Request for Class II Permissive Change

FCC ID: VG8EM025FXX-Y

Please be notified that we, the undersigned, **Guangdong Midea Kitchen Appliances Manufacturing Co.,Ltd.** declare that the reasons for this class II permissive change are as below:

1. Changed mother board as below.

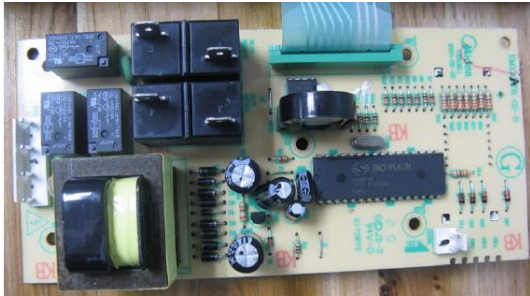
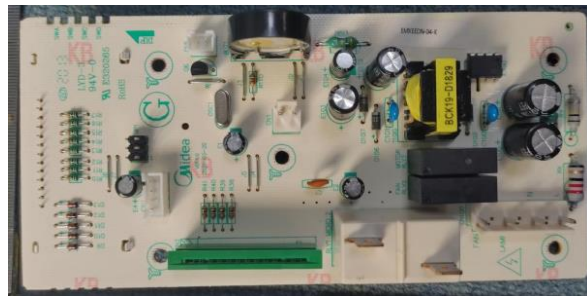
Note : New mother board uses switching power supply instead of the original linear transformer. The product's input/output rating and power are identical to the original. Only some electronic components and PCB layout differences.
